February 2, 2024

**LINCOLN PUBLIC SCHOOLS
ARTS & HUMANITIES FOCUS PROGRAM – ENHANCEMENT PROJECT
LINCOLN, NEBRASKA**

ADDENDA #2

C1.0

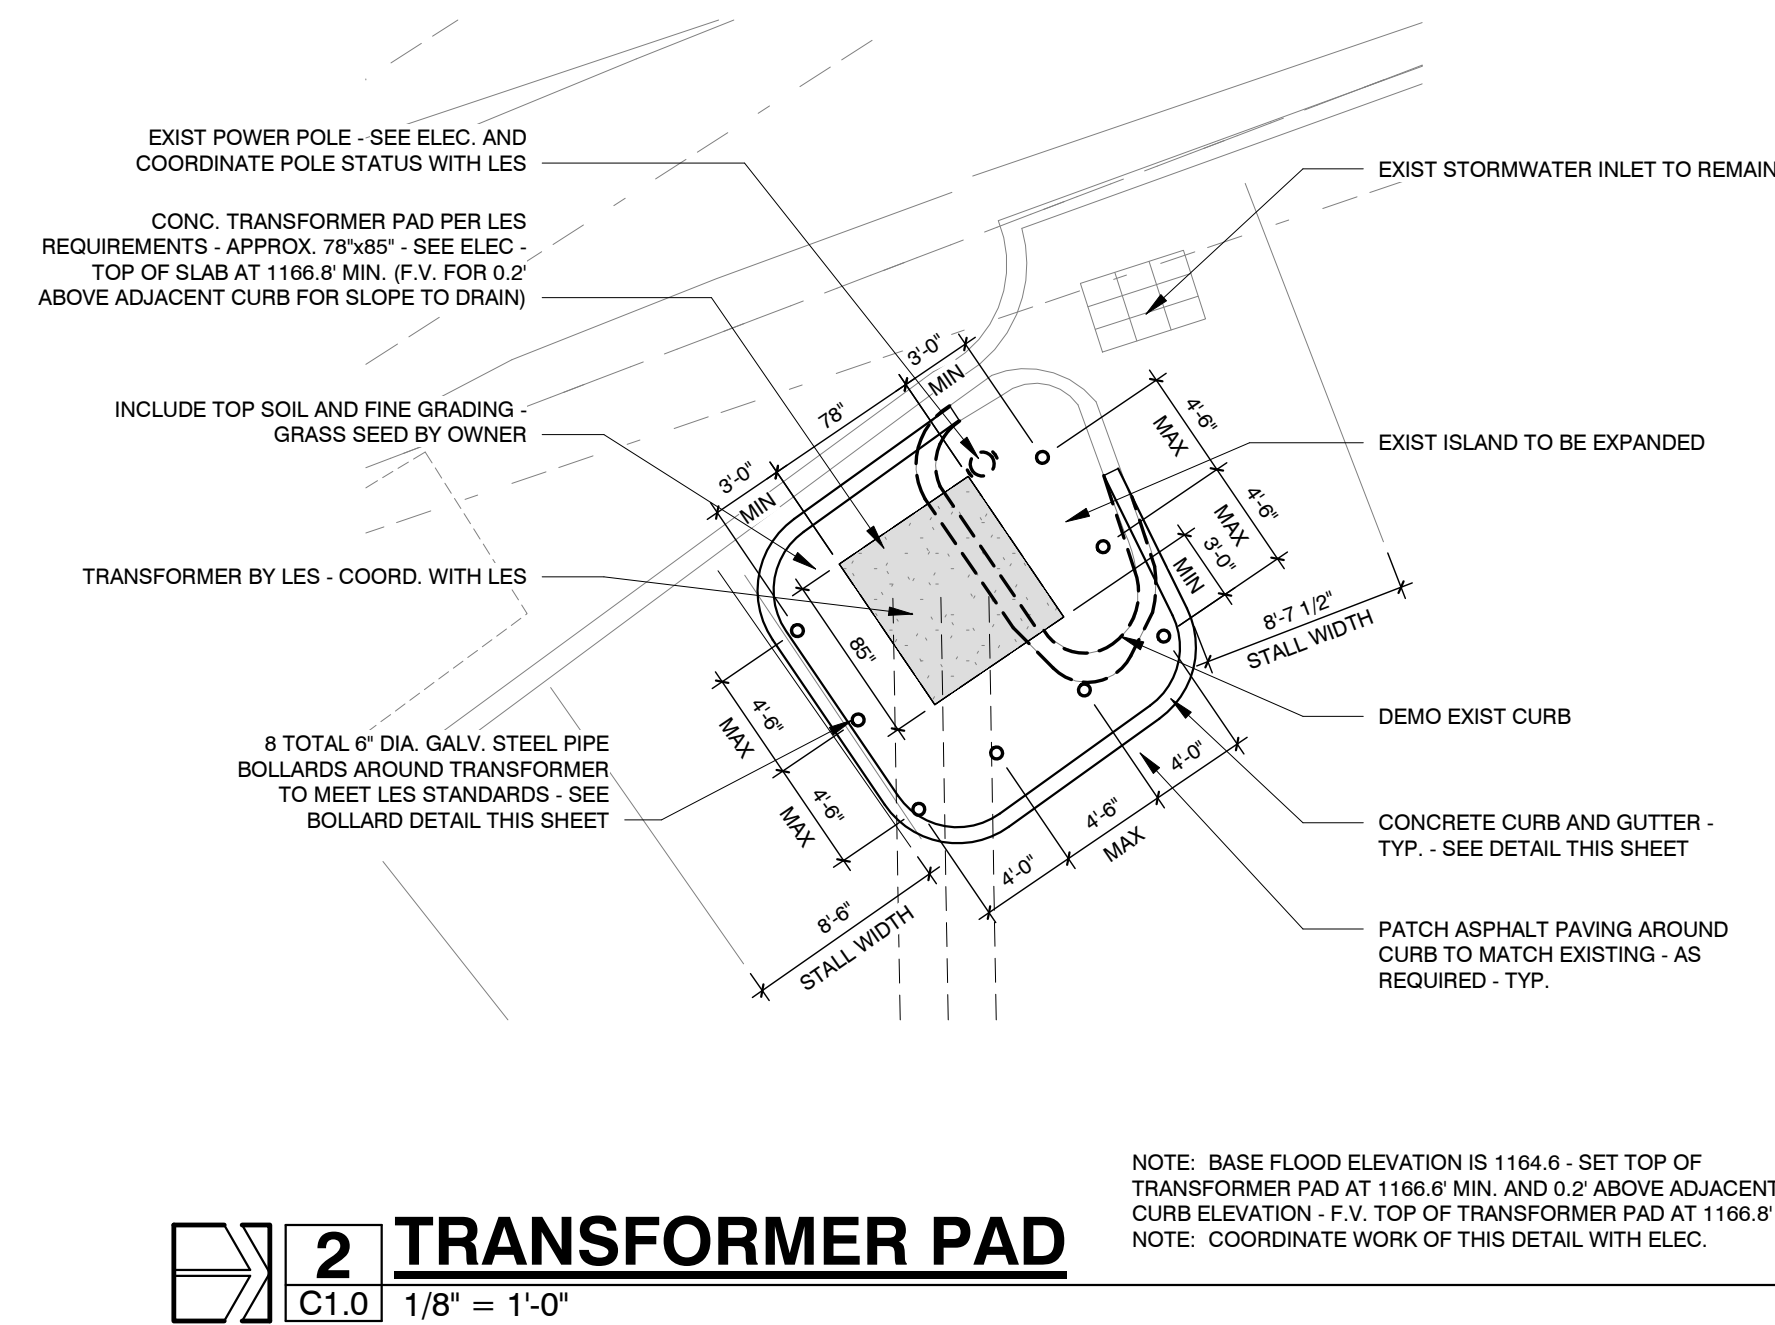
- A. At 'Site Overall Plan – Detail 1', make the following changes:
1. Add the SS300 Gutter Buddy by Silt Saver or approved equal, to protect the curb inlet.

2. Revise the extend of the staging area to show both properties 2403 J Street and 2411 J Street included in the staging area.
 3. Add the following note: "EXISTING VACANT PROPERTIES AT 2403 J STREET AND AT 2411 J STREET ARE OWNED BY LPS AND ARE AVAILABLE FOR CONTRACTOR PARKING AND STAGING - FIELD VERIFY LOT SIZES - RESTORE LOTS TO PRE-CONSTRUCTION CONDITION AT END OF PROJECT".

4. Add a rock pavement construction entrance at the staging area and add the following note: "STABILIZED ROCK CONSTRUCTION ENTRANCE - SEE DETAIL 5 SHEET C1.0".

5. At the north building wall, at the note that reads: "LPS TO REPAIR EXIST. DAMAGED STORM DRAIN LINE", add a note that this work has been completed by LPS.

6. At the north building wall, at the note that reads: "LPS TO EXTEND STROM DRAIN TO ABOVE GRADE AND CONTRACTOR TO CONNECT DOWNSPOUTS", add a note that this work has been completed by LPS.

7. Add the following note at the City water main at the drive east of Grounds 121: "SAWCUT, REMOVE AND PATCH EXIST. CONC. SLAB ON GRADE PAVING TO MATCH EXIST. AND TO MEET CITY OF LINCOLN STANDARDS - AS REQUIRED TO CAP AND ABANDON EXISTING WATER SERVICE PIPE SERVING SPEC. ED ROOM 122M – INCLUDE EXCAVATION AND RE-COMPACT BACKFILL AS NEEDED - COORD. WITH MECH. – COORD. WITH OWNER RE. ACCESS".

8. Add the following at the City water main: "SAWCUT, REMOVE AND PATCH EXIST. CONC. SLAB ON GRADE PAVING (INCLUDING CONC. CURB IF REQUIRED) TO MATCH EXIST. AND TO MEET CITY OF LINCOLN STANDARDS - AS REQUIRED TO CAP AND ABANDON EXISTING WATER SERVICE PIPE SERVING ENVIRONMENTAL ROOM 104 - – INCLUDE EXCAVATION AND RE-COMPACT BACKFILL AS NEEDED - COORD. WITH MECH. – COORD. WITH OWNER RE. ACCESS. - COORD. WITH MECH. – COORD. WITH OWNER RE.

- B. Add Detail 5, C1.0 – 'Stabilized Construction Entrance'.

3 JOIST REINFORCING DETAIL
S1.2 SCALE: 3/4" = 1'-0"

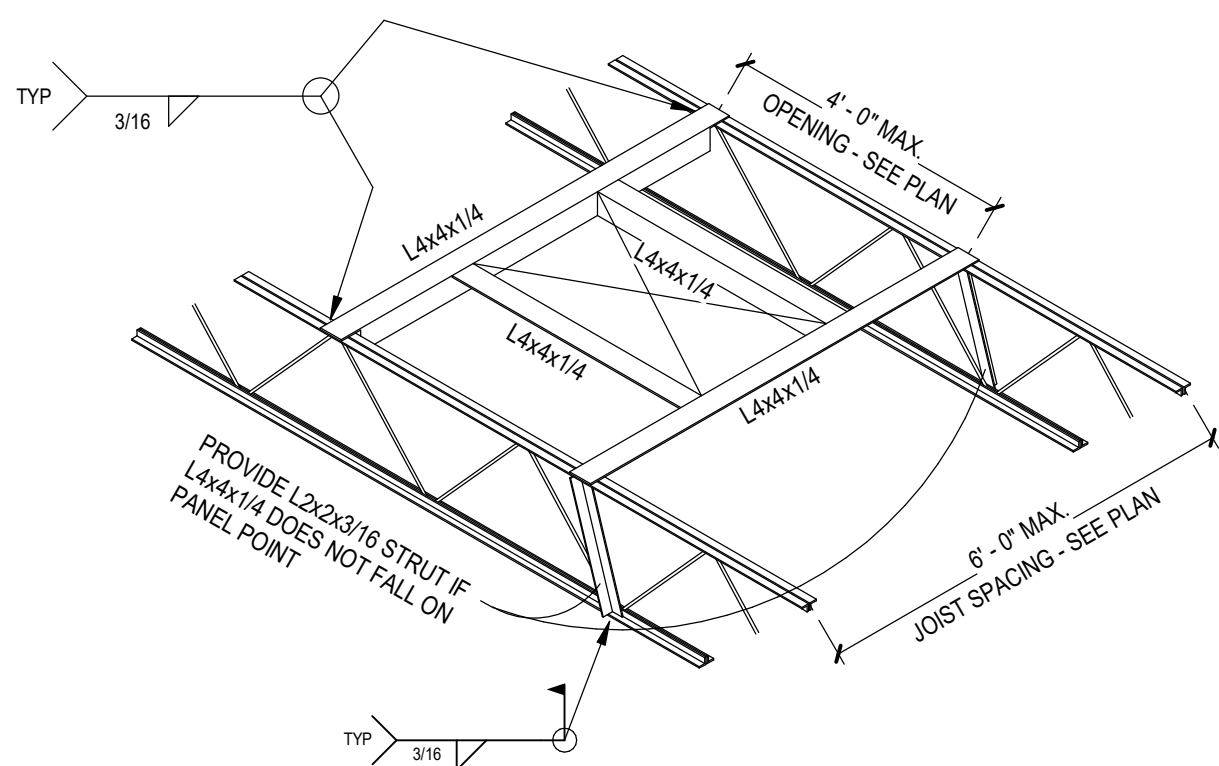
- A. Add detail 3, Sheet S1.2. Provide joist reinforcing at any joist attachment load of over 50 pounds that does not occur at a joist panel point.

- General Coordination, Add I.; ATTACHEMENT POINTS FOR PIPE, DUCT AND CONDUIT, WITH AN ATTACHEMENT POINT LOAD OF 50 LB OR GREATER, NEED TO BE LOCATED AT JOIST PANEL POINTS OR ELSE JOIST REINFORCING IS REQUIRED PER THE ATTACHED DETAIL 3 ON S1.2.

1 OVERALL PLUMBING PLAN
P1.1 3/32" = 1'-0"

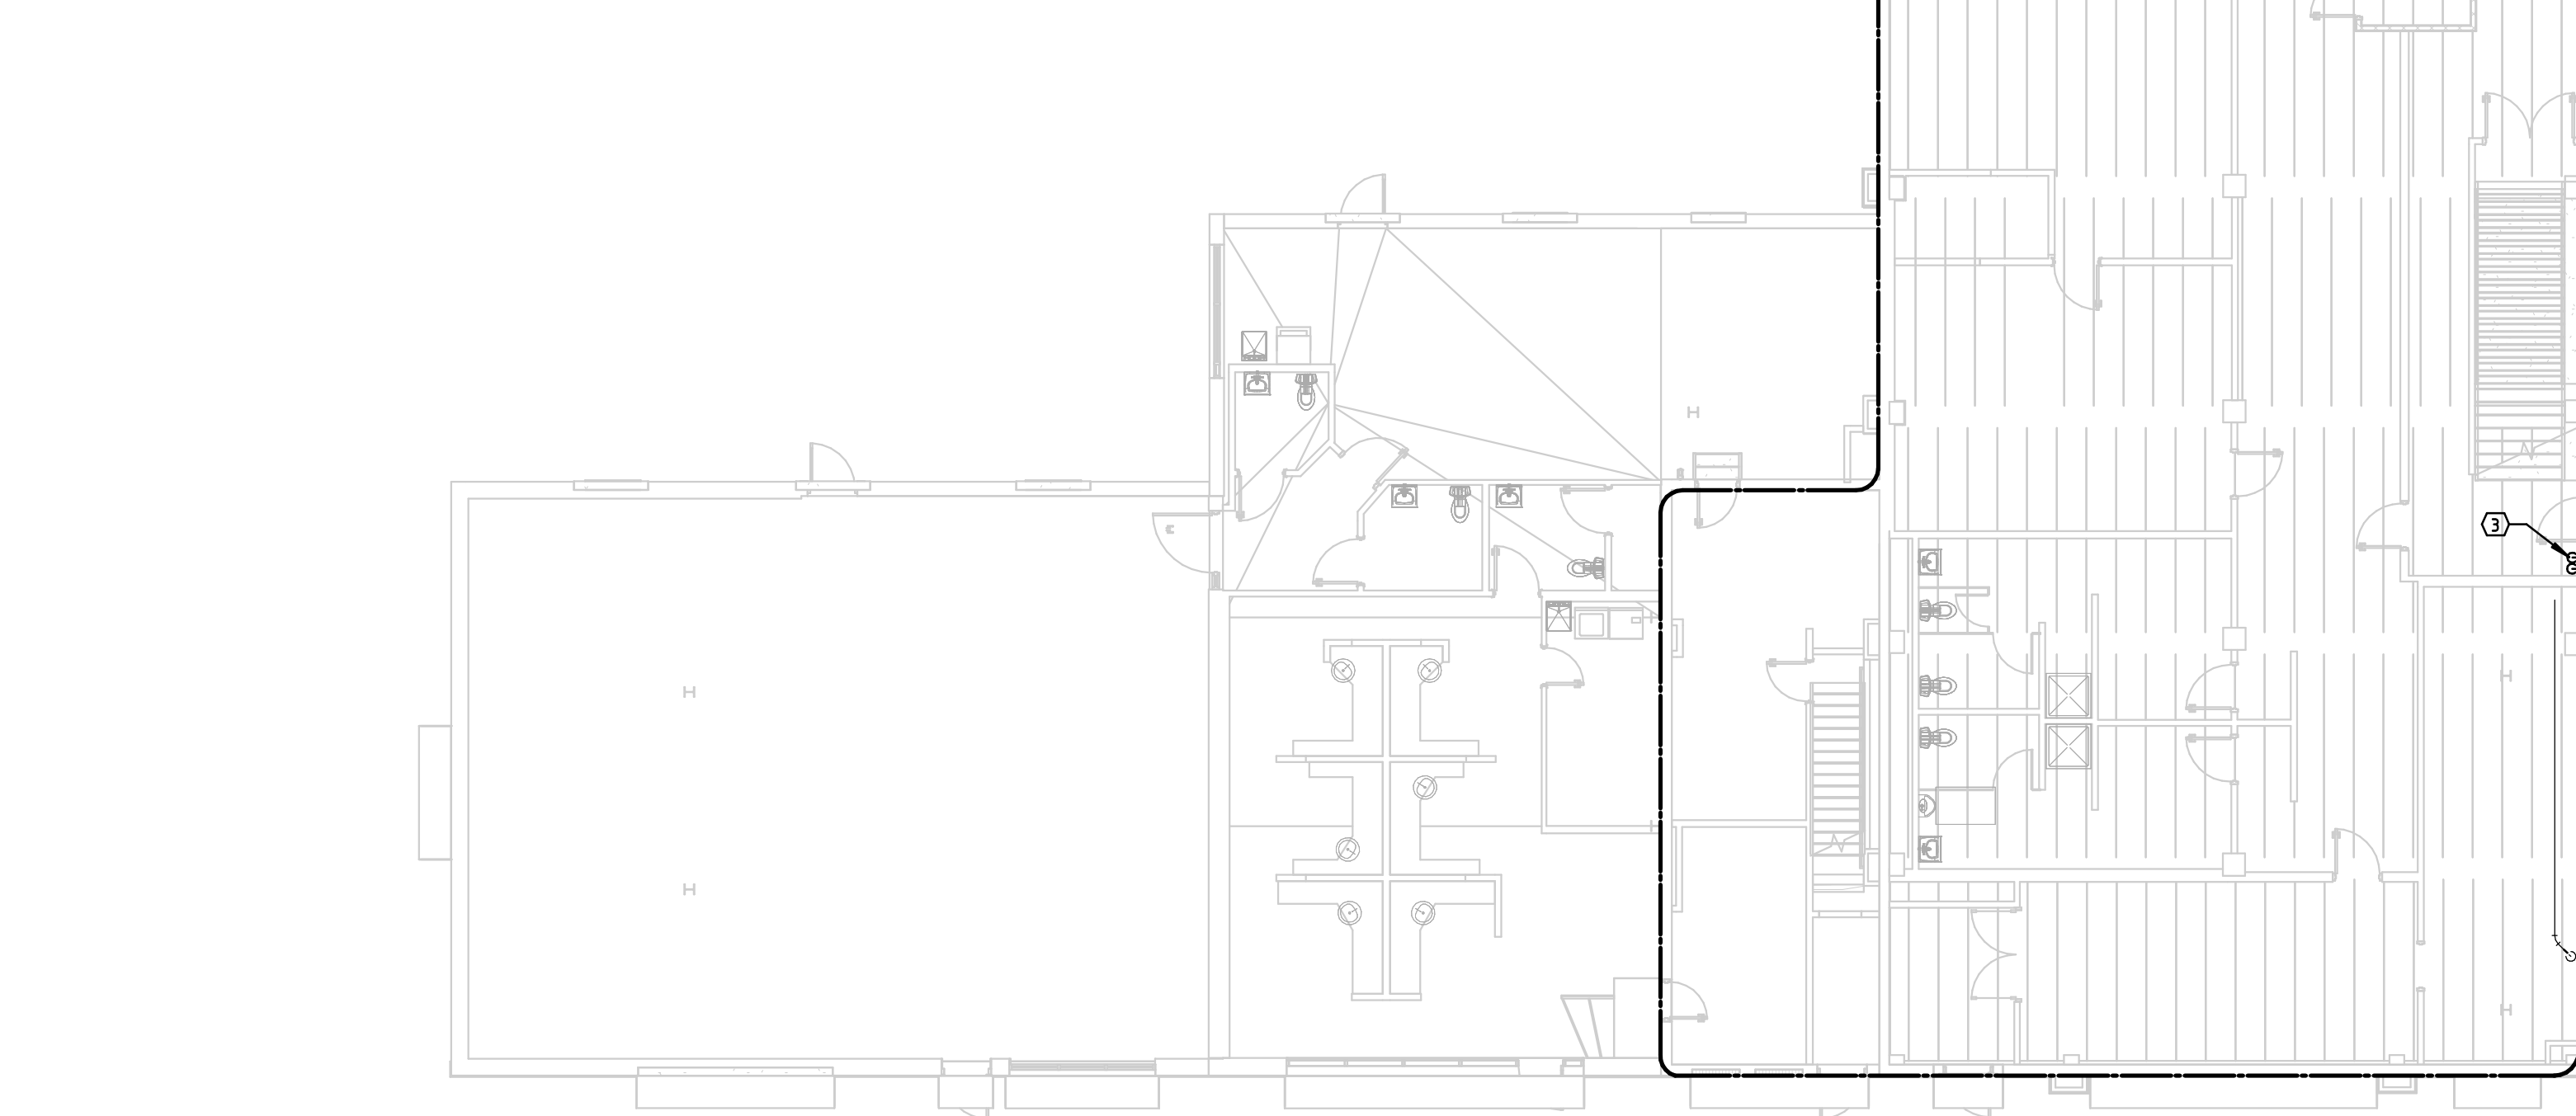
- Grounds 120; 2" DCW pipe running east/west in room, Added Keynote #6: "SUPPORT PIPE FROM METAL BUILDING FRAME WHERE PIPING RUNS IN EAST/WEST DIRECTION."
- Keynote #4, revise to read: ROUTE PIPING AS HIGH AS POSSIBLE THROUGH AREAS WITHOUT CEILING, COORDINATE EXACT LOCATION AND ROUTING WITH EXISTING CONDITIONS. ROUTE PIPING THROUGH JOIST SPACE WHERE POSSIBLE. CONTRACTOR TO VERIFY PIPE SUPPORT TYPE REQUIRED IN EACH SPACE.

1 FAUCET / HOSE BIBB DETAIL
P3.1 NTS

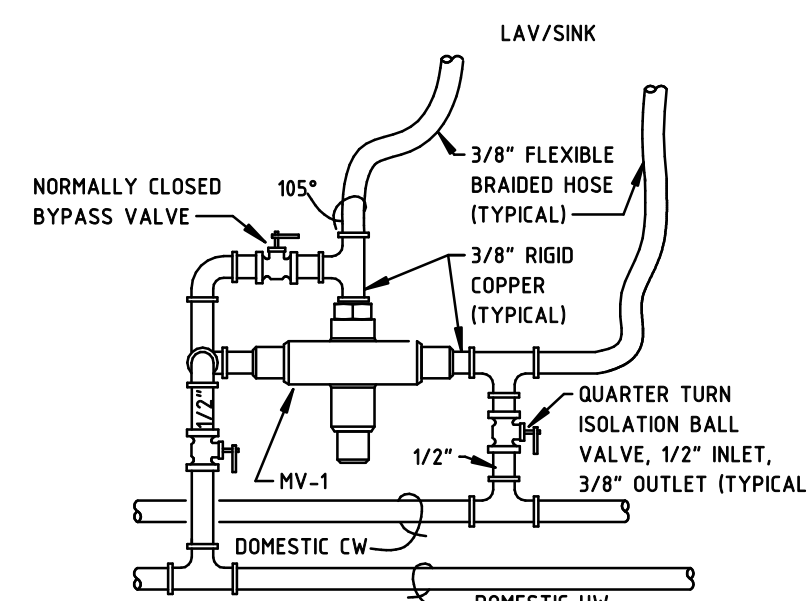
- Revised backflow preventer note to read; "PROVIDE 1/2" RPZ BACKFLOW PREVENTER FOR HOSE BIBB AT AN EASILY ACCESSIBLE LOCATION. ALL BACKFLOW PREVENTERS TO BE TESTED PER AWWA M14 CROSS CONNECTION CONTROL AND LOCAL AUTHORITY BY A REGISTERED GRADE VI WATER OPERATOR AND PROVIDE SUMMARY REPORT AT PROJECT CLOSEOUT."
